Ch11 Sec2 Fillet welding

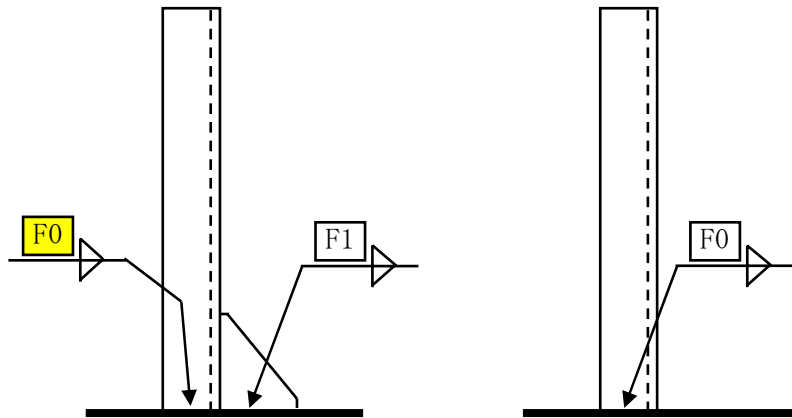
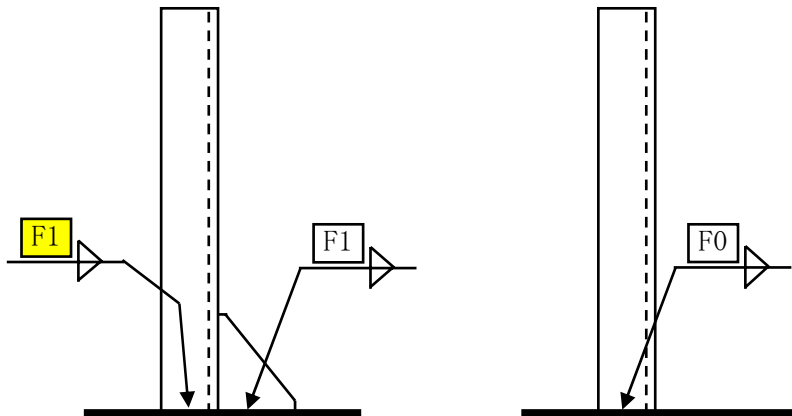
With reference to Table 2, the required fillet welding are as follows;

We think it acceptable to apply fillet welding as follows;

Please confirm the above.
